## Memorandum

**Re:** Interstate 80/Gilman Street Interchange Improvement Project  
– Addendum to the Technical Reports  
District 04 - ALA - 80 - PostMiles 6.38 / 6.95  
EA 04-0A7700 / Project ID# 0400020155

### 1.1 ADDENDUM OF FIGURE REVISIONS

Figure 2. Project Location

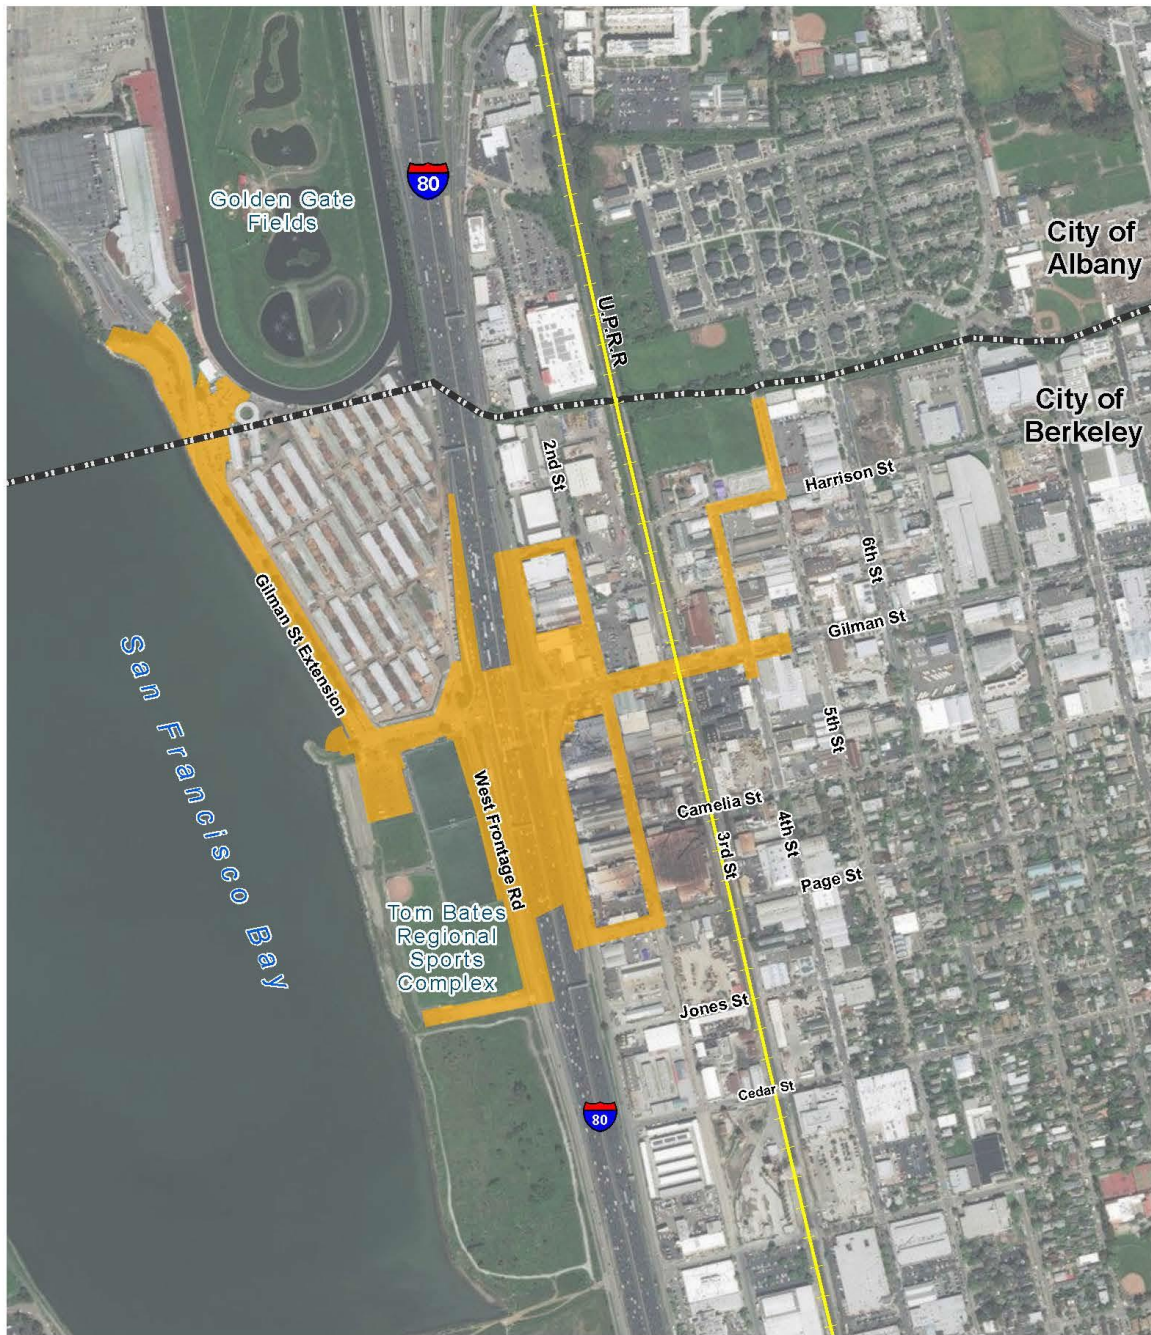
This addendum updates the project footprint and study area boundary depicted in various figures in the technical reports prepared for the Interstate 80 (I-80)/Gilman Street Interchange Improvement Project. This revision to the project footprint and study area boundary does not result in any change in the affected environment or potential impacts, and the findings presented in the previously approved technical reports remain valid. The technical reports, figure number, and figure name included in this addendum are identified below. The revised figures are attached at the end of this memorandum.

Figure 2. Project Location

Figure 4. Geologic Map

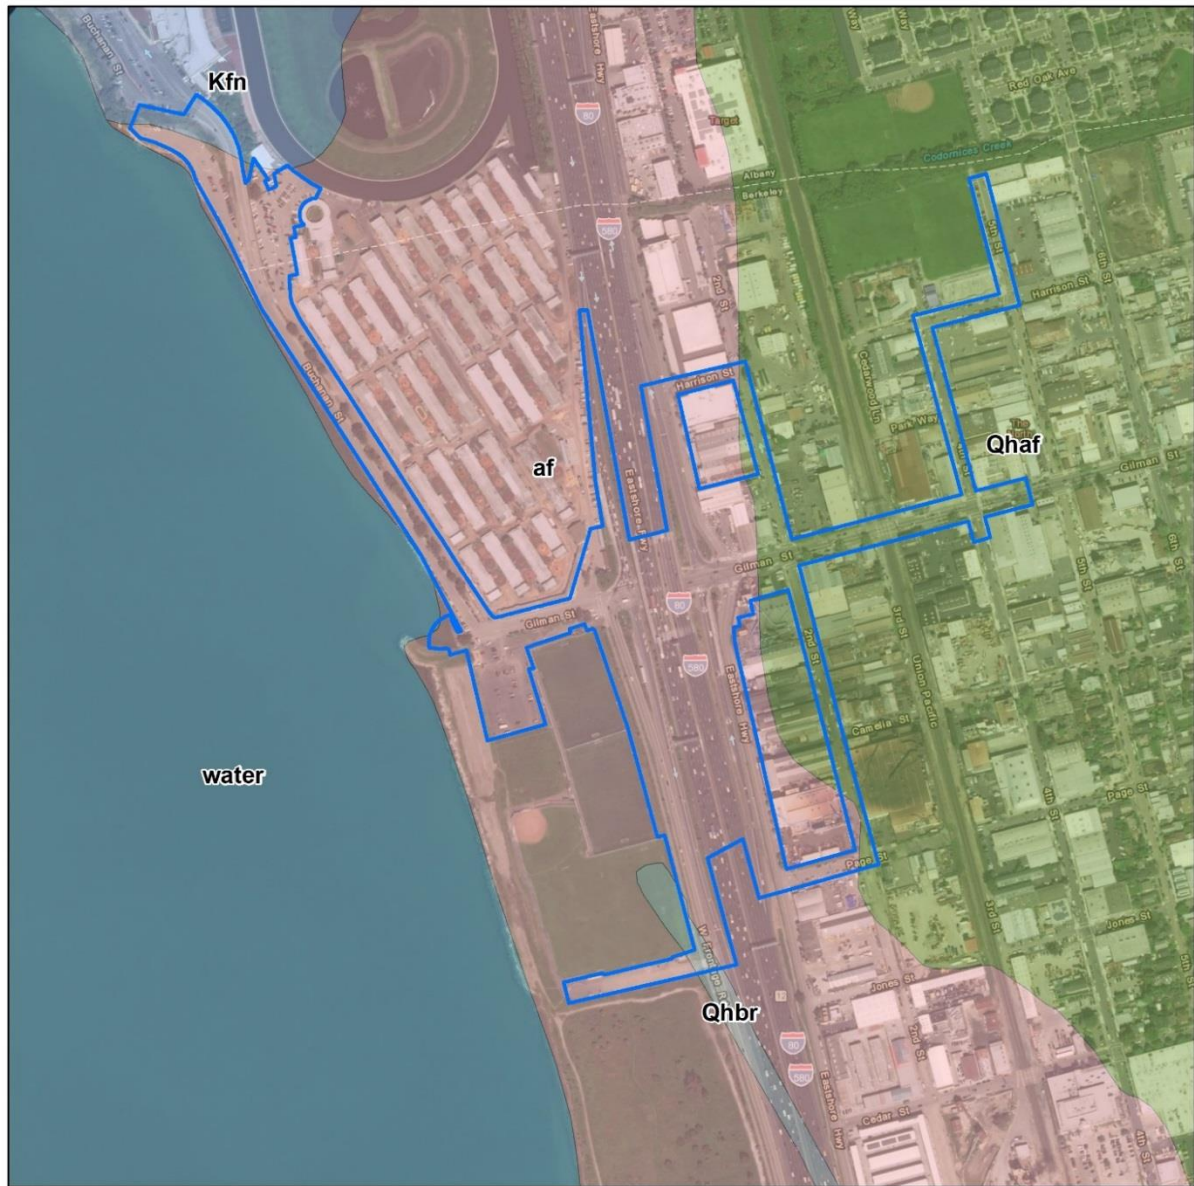
Figure 4. Geologic Map

Figure 2: Project Location

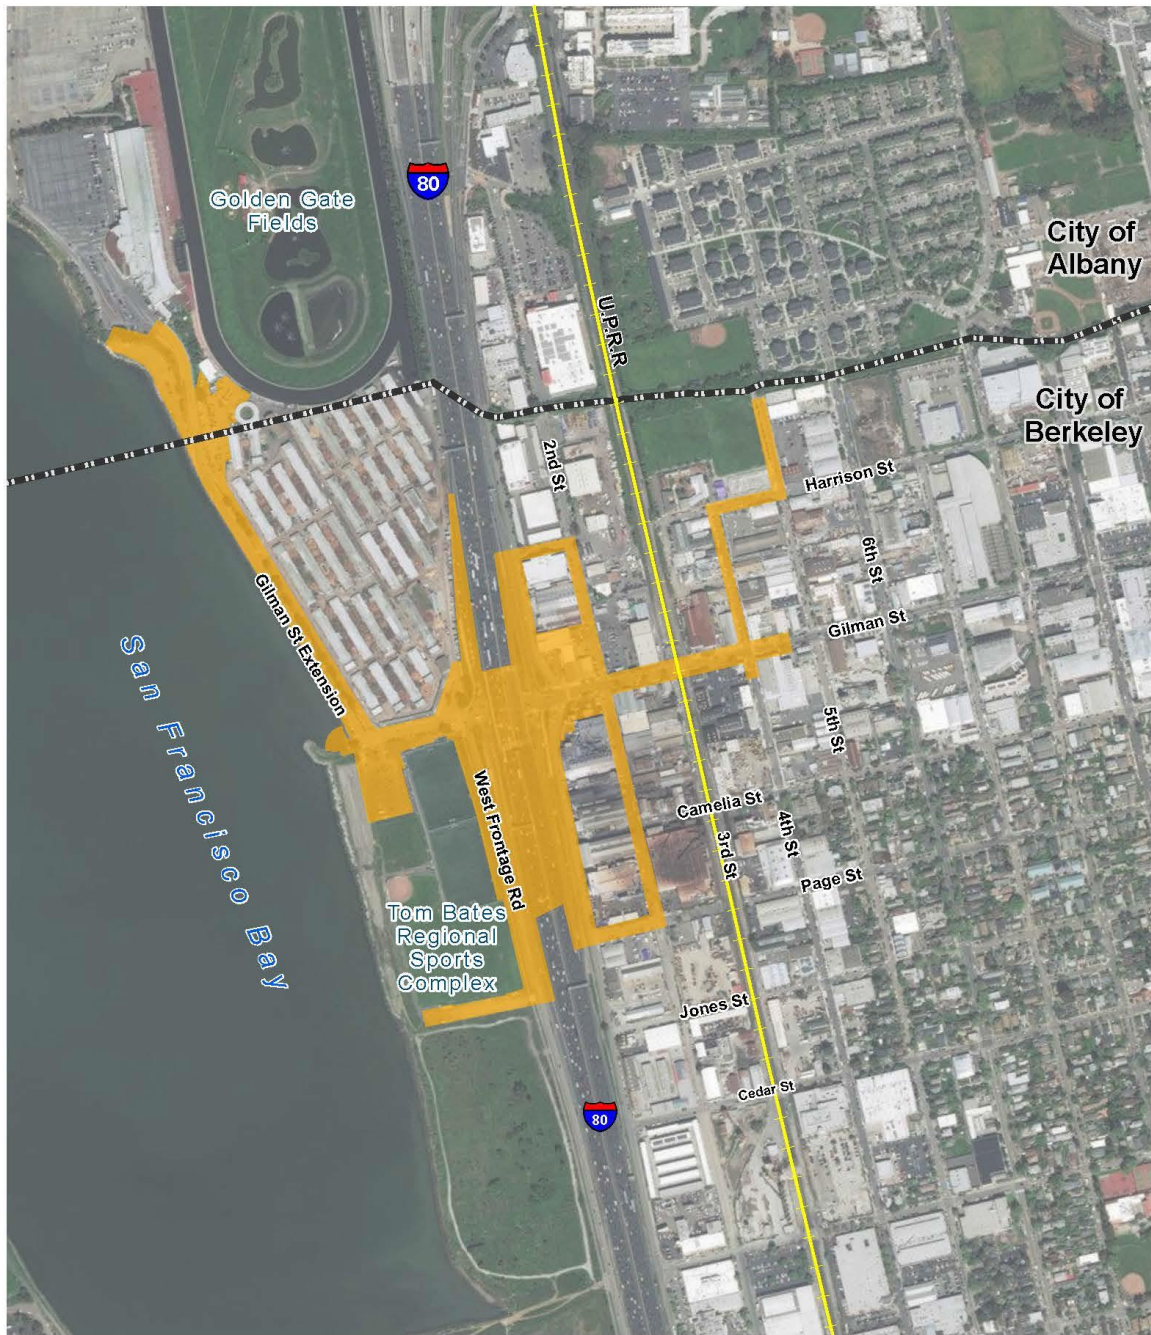
Figure 2: Project Location

Figure 3: Visual Assessment Units

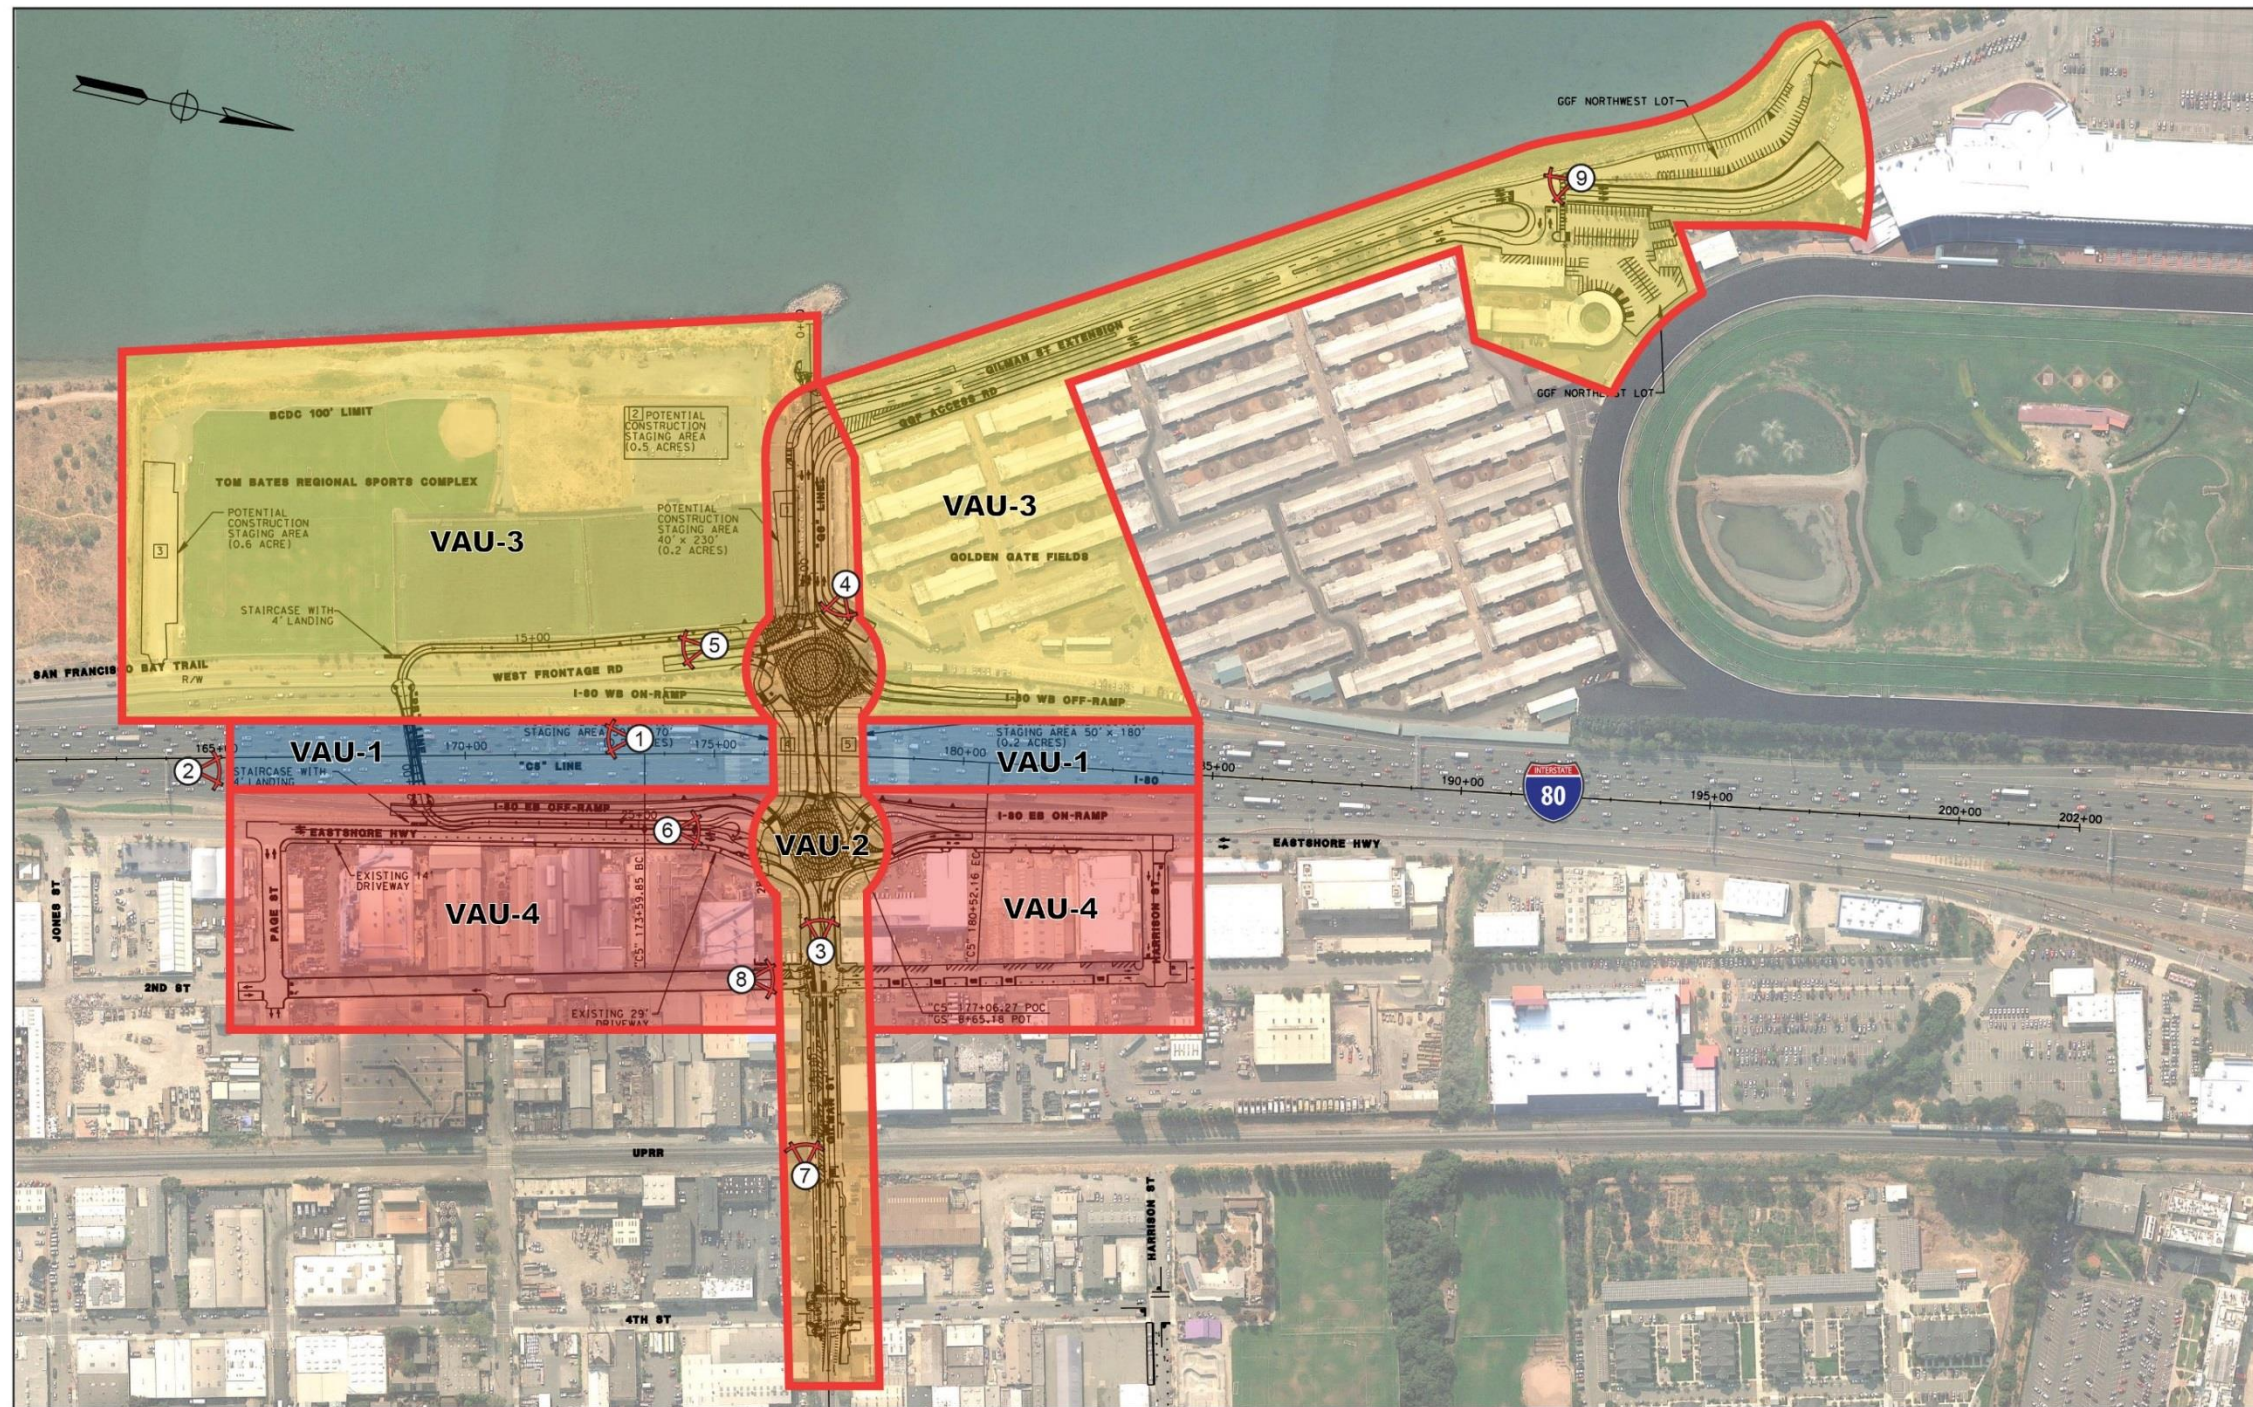
Figure 3: Visual Assessment Units
